TITLE:	6" WATER LINE EXTENSION
ALONG JUAN TABO BLVD., BETWEEN MOUNTAIN RD. AND SUMMER AVE. N.E.

DRAWING NO.	1476
MAP NO.	J-22 S
SHEET	1
OF	1

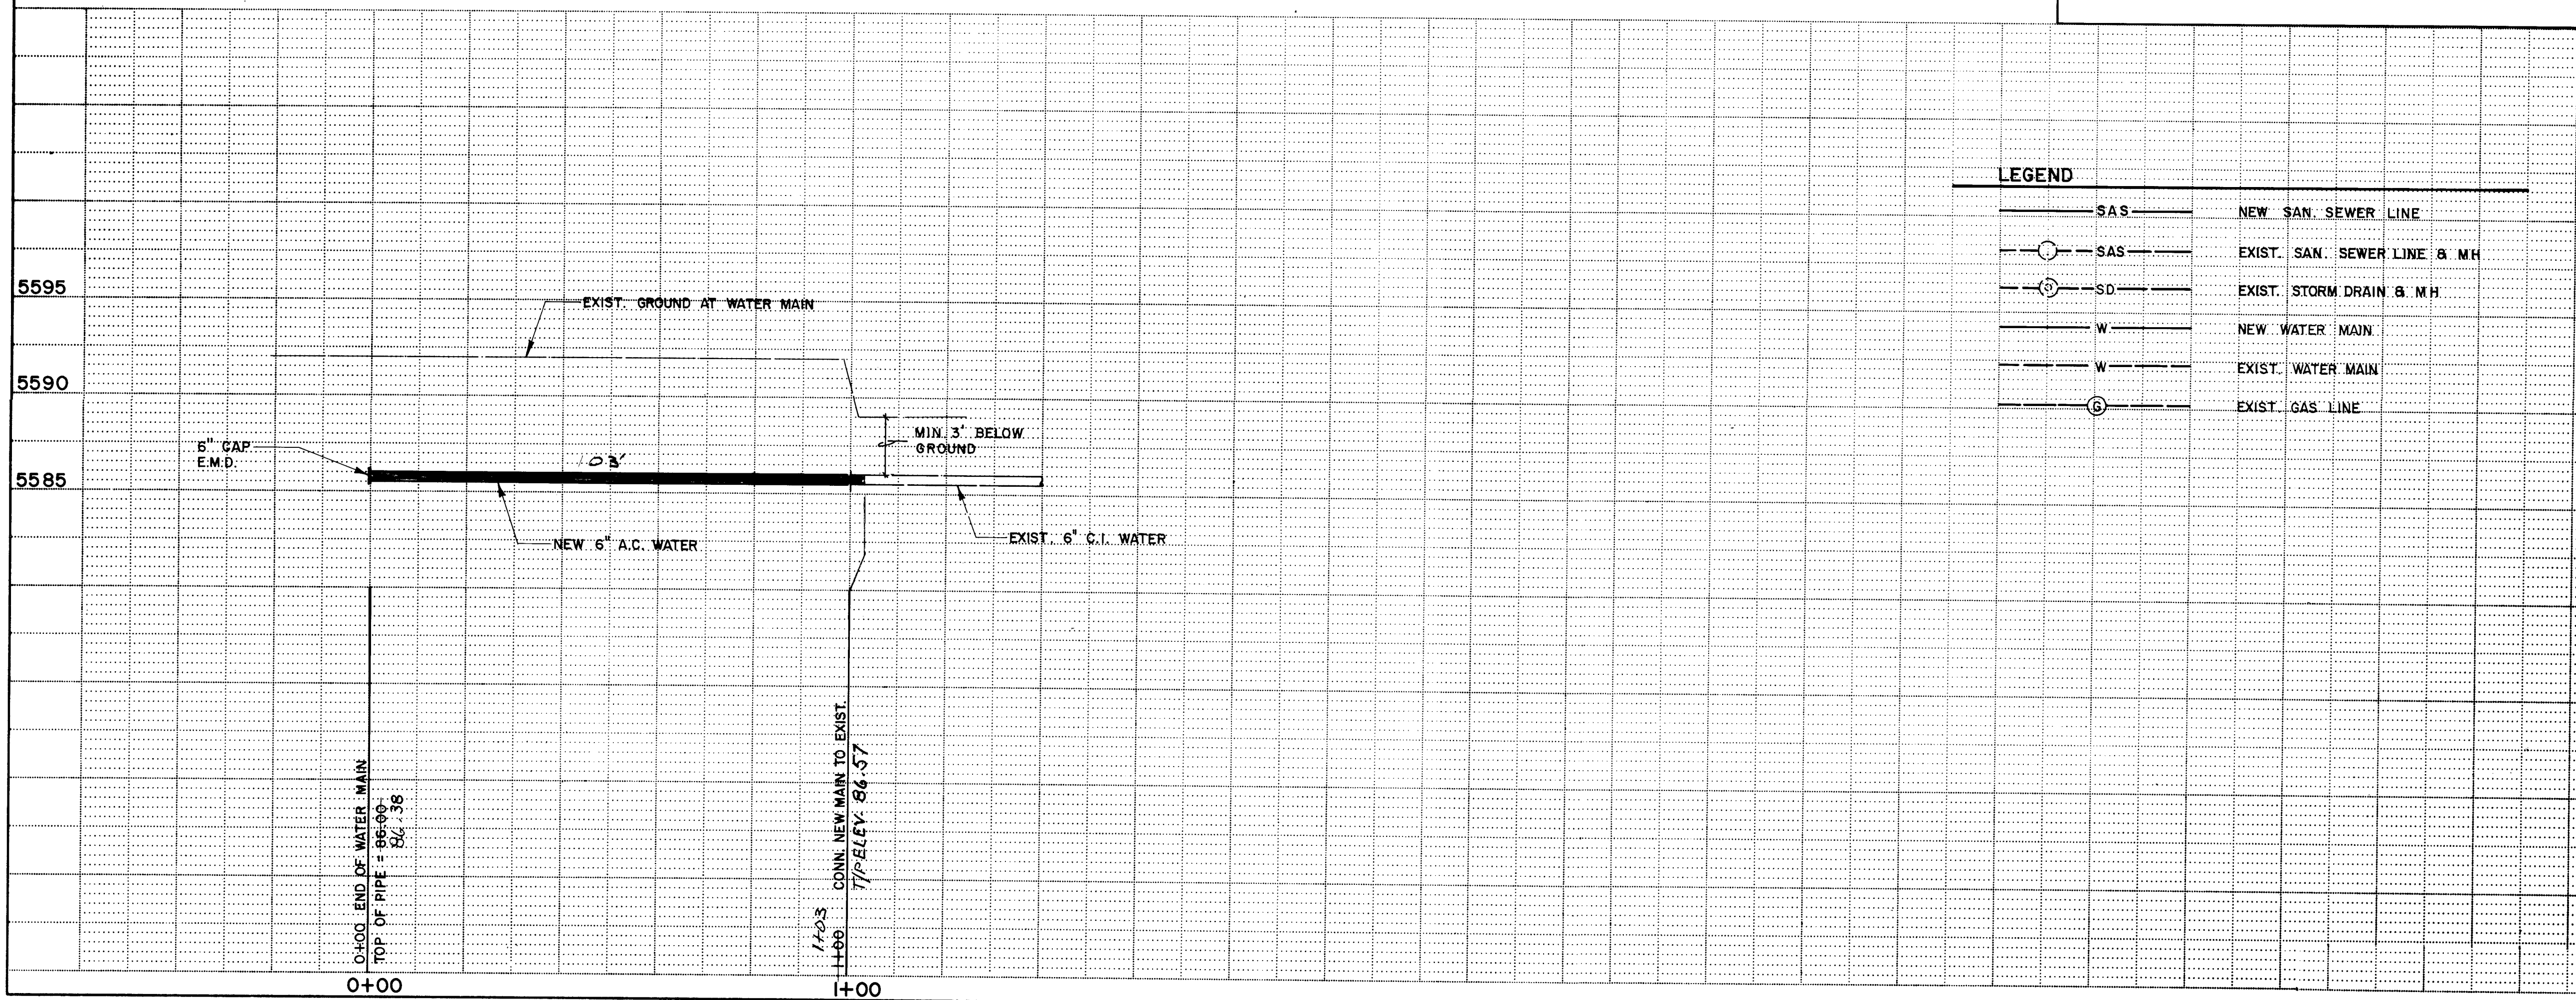
SEWER SERVICE NOT PRESENT IN JUAN TABO

4" SEWER SERVICE	75	LF
REM. & REPL. ART. PAVE	21	SY
REM. & REPL. C & G	10	LF
REM. & REPL. ASPH. CURB (MEDIAN)	10	LF
